# Service Bulletin

S.B. No: 188

**Title:** INSPECTION FOR RUDDER PEDAL CLEARANCES BETWEEN RUDDER PEDALS AND THE AIRCRAFT STRUCTURE AND COMPONENTS ALSO INSPECTION FOR GROUND TOWING DAMAGE.

**Applicability:** T67B, T67C series, T67M (excluding works no. 1999), T67M-MkII and T67M200 (excluding works no. 2264 & 2265).

**FIGURE 9**  
**BRAKE MASTER CYLINDER SUPPORT BRACKETS**

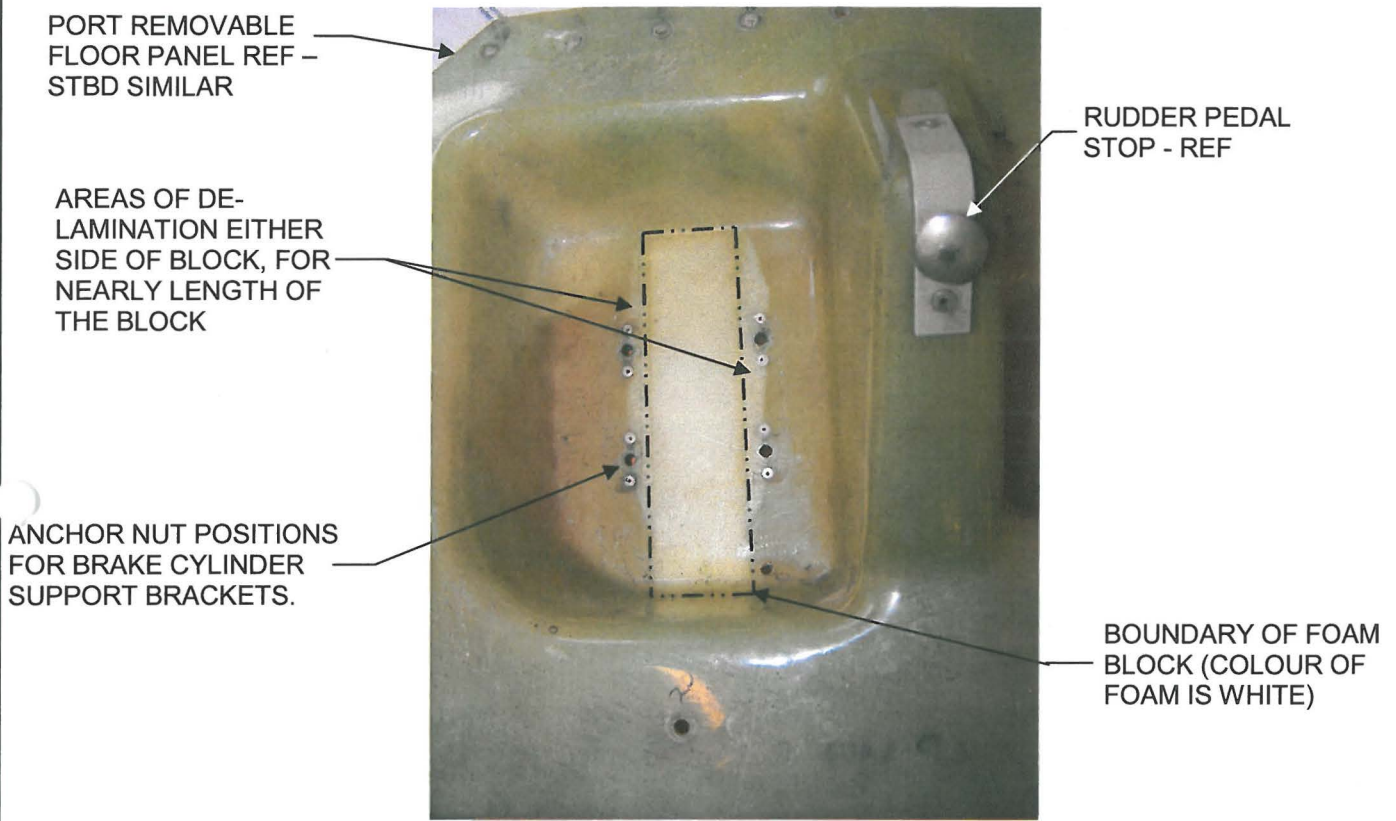
9. Ensure that there is no gap at the brake master cylinder pivot points and that the support brackets are securely mounted to the floor panel, i.e. not loose, they should not deflect if base fastenings are sound. If bracket is seen to be suspect, i.e. out of square, twisted or bent, remove brackets and replace with new brackets if damaged. Check that there is no damage to the bracket anchorages in the removable floor panel, damage will show as whitening in the laminate surrounding the anchor nuts and foam reinforcement block, if in doubt remove panel and check anchor nuts for security. Figure 9 refers. The floor panel if found to be damaged is to be repaired or new panel fitted, refer to SACL Customer Support Department. If damage found then proceed as indicated by paragraphs 10 and 11. When rectified ensure all clearances and checks are accomplished as related to in this Service Bulletin.

11. If damage is found ref. Paragraph 9, then brake master cylinder to rudder pedal carriage attachment pin is to be checked for deformation/cracking, Figure 9 refers.

FIGURE 10

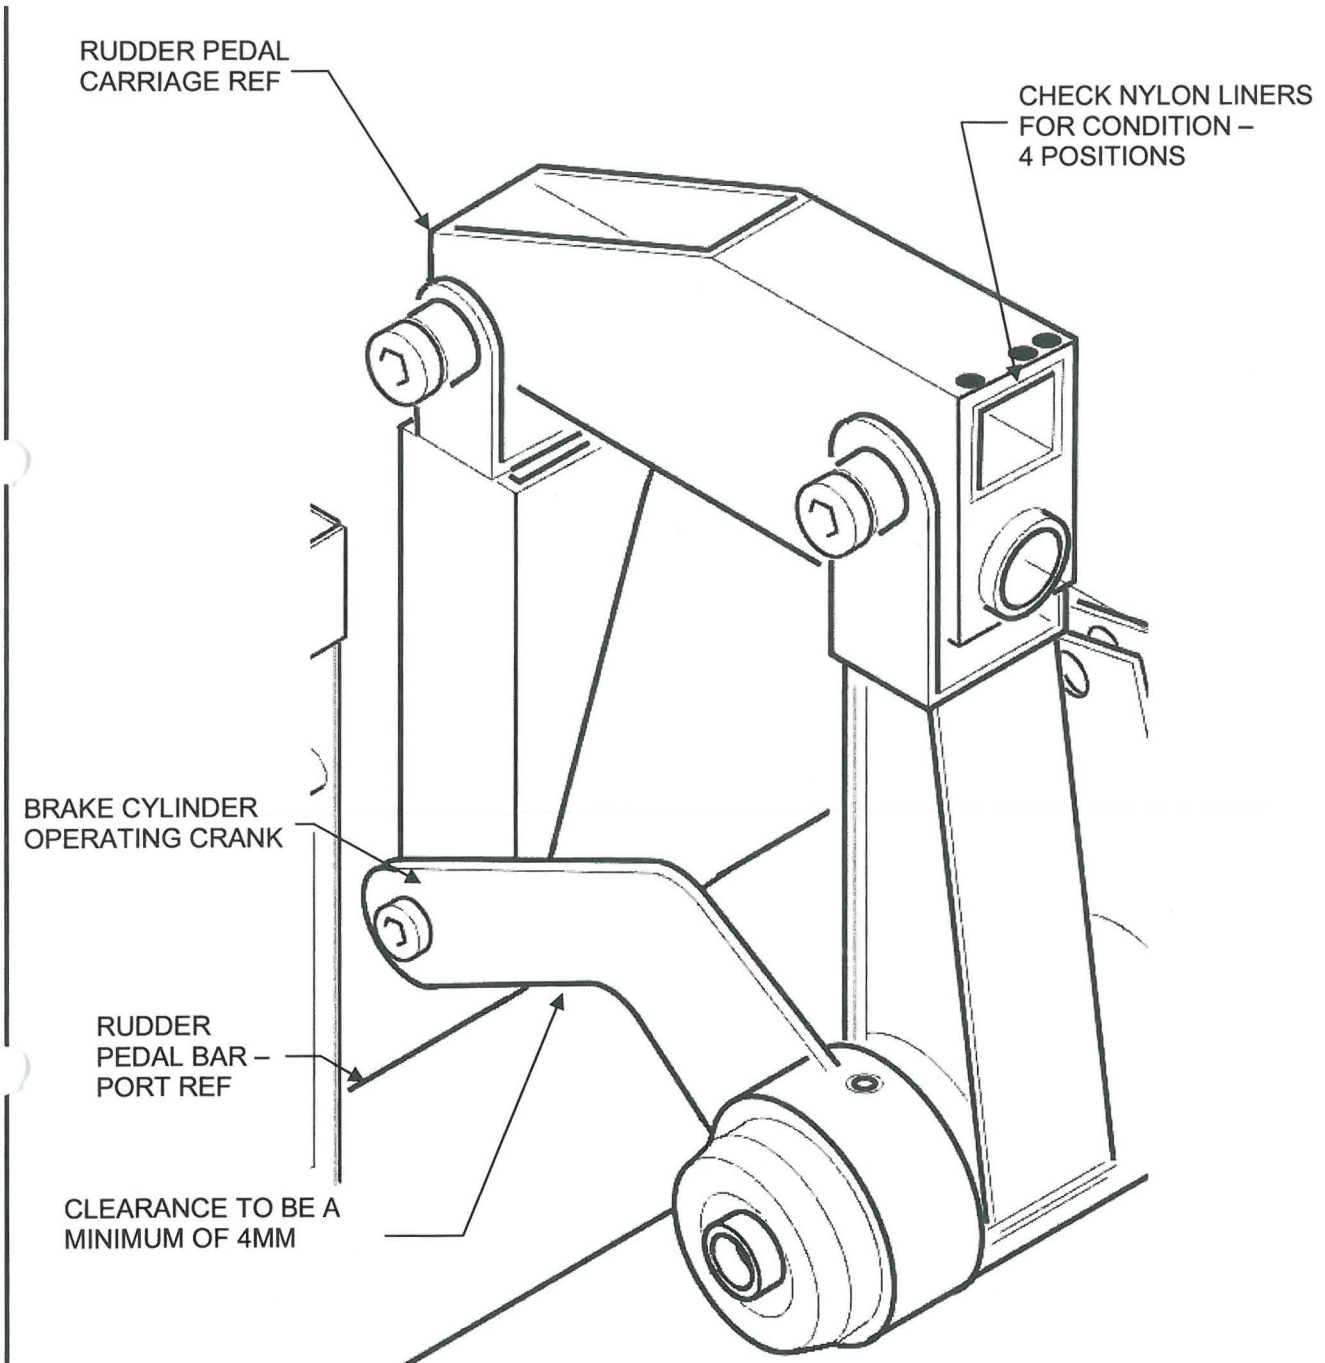
23. Ensure that all the nylon liners in the rudder pedal carriages are fitted, (4 pieces per carriage in Pre-Mod M450\* aircraft, 1 piece liner in Post Mod M450) and are in a good condition and not worn, Figure 10 refers, replace liners if unsatisfactory. Return carriages to SACL for replacement of liner.

26. Ensure that the brake operating crank, as shown at Figure 10, has a minimum clearance of 4mm relative to the rudder pedal bar following all checks and rectifications. Allow for various brake conditions, refer paragraph 29.2. Should bar show signs of chaffing check depth of groove. If depth is 0.0mm to 0.5mm, remove rudder bar, blend out groove, repaint and refit. If the groove is to a depth greater than 0.5mm, remove rudder bar and return to SACL for repair or replacement.
